**SUBJECT:** Savannah River Site's Responses to the Regulatory Comments on the 2020 K-Area Burning/Rubble Pit and Rubble Pile (131-K and 631-20G) (KBRP) and P-Area Burning/Rubble Pit (131-P) (PBRP) Operable Units Combined Groundwater Monitoring Report (Sampling Summary) SEMS Numbers: 40 and 59

SRS Responses to EPA Comments on the 2020 K-Area Burning/Rubble Pit and Rubble Pile (131-K and 631-20G) (KBRP) and P-Area Burning/Rubble Pit (131-P) (PBRP) Operable Units Combined Groundwater Monitoring Report (Sampling Summary) SEMS Numbers: 40 and 59

Figure 1. PAGW OU Upper Aquifer Zone Potentiometric Surface

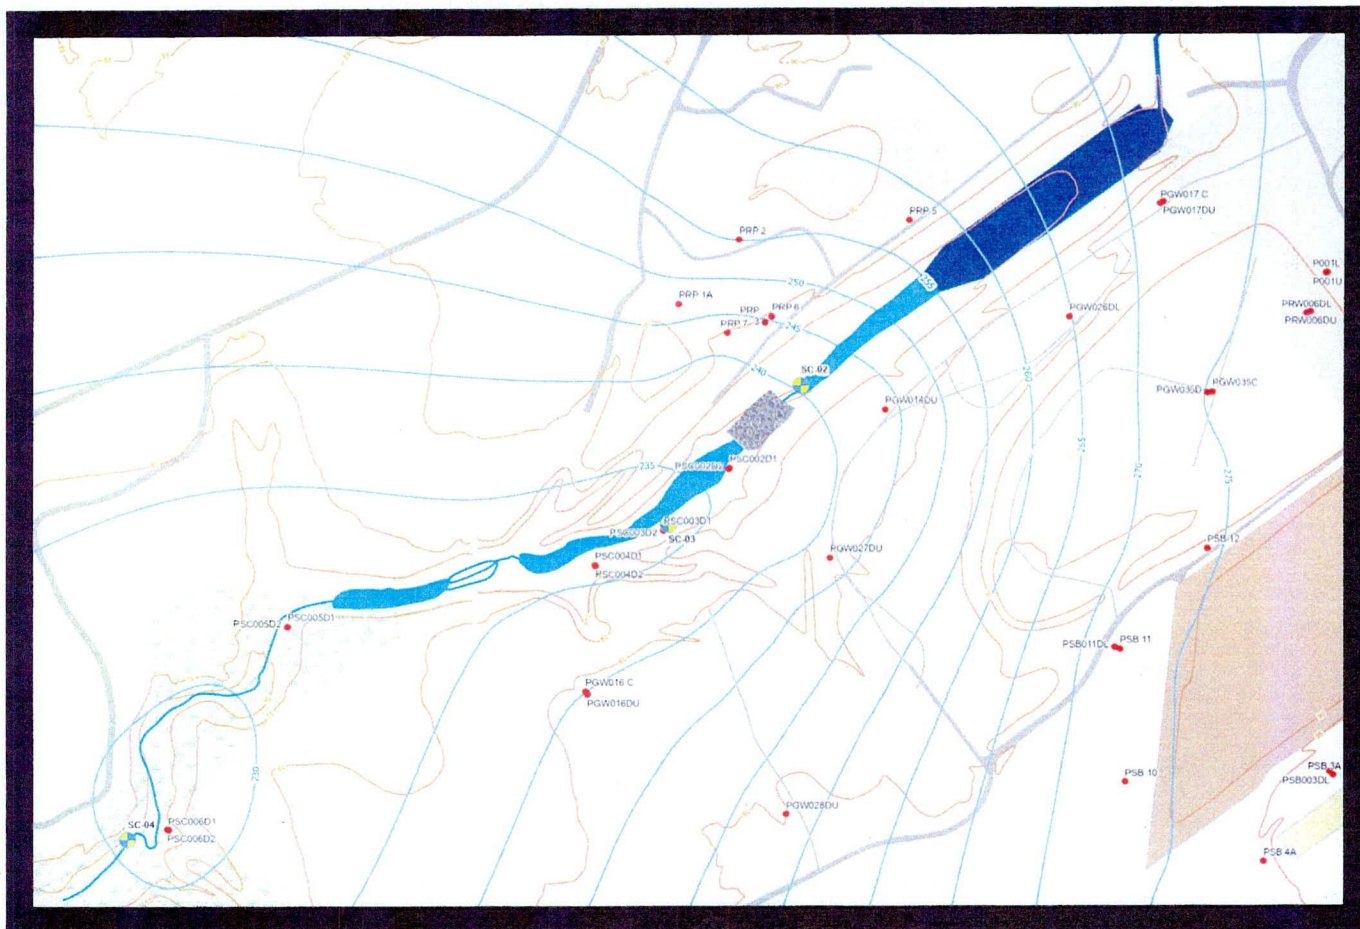
- 2. P-Area Burning/Rubble Pit (PBRP) OU, Page 7:** Based on the information presented, the groundwater flow direction at the PBRP OU is uncertain. For example, the text in this section states the groundwater flow is to the southwest as shown on Figure 7 (PBRP Monitoring Well Network, 1,1-DCE Values, and Water Elevation Measurements During 4Q2020), Page 12. However, based on the northeast-southwest linear alignment of monitoring wells PRP 5, PRP 6 and PRP 7, insufficient triangulation between the monitoring

wells creates uncertainty in the groundwater flow direction. To reduce the uncertainty, a monitoring well on the north side of the PBRP OU is needed to address this data gap in local groundwater flow direction. Based on the topographic contours, southeasterly groundwater flow towards Steel Creek is probable. *Please revise the 2020 Sampling Report to address this issue to ensure groundwater flow direction at the PBRP OU is adequately characterized.*

Sampling optimizations that were developed and approved by USEPA and SCDHEC and presented in the *Standardizing Sampling and Reporting Requirements P, L and K Area Burning Rubble Pits* (see ACP-08-133, dated January 15, 2008) continued at PBRP in 2020. The approved groundwater network consists of three wells (PRP 5, PRP 6 and PRP 7). As an alternative to installing an additional well to the north side of the PBRP OU, SRS plans to augment the existing monitoring network with the addition of existing wells as described below.

Several wells within the P Area are sampled for synchronous water elevations in the first and third quarters as part of the P-Area Groundwater (PAGW) OU network (including wells PRP 1A and PRP 2, located north of the PBRP OU). Figure 1 (attached) shows the potentiometric surface based on this larger set of wells. Water elevations gathered from several wells within the PAGW OU monitoring network, near the PBRP OU, will be used to construct a more comprehensive potentiometric surface to provide sufficient triangulation and reduce the uncertainty associated with groundwater flow beneath the unit.

A table that is similar to Table 1 below will be included in future reports to identify the wells used to determine the potentiometric surface. An explanation of the additional wells that help with determining groundwater flow direction will also be included with language similar to the following:

“To better define the groundwater flow direction beneath the PBRP OU, selected wells from within the PAGW OU monitoring network (Table 1) will be used to help evaluate the potentiometric surface in the area. All water elevations will be collected in the third quarter of the year.”
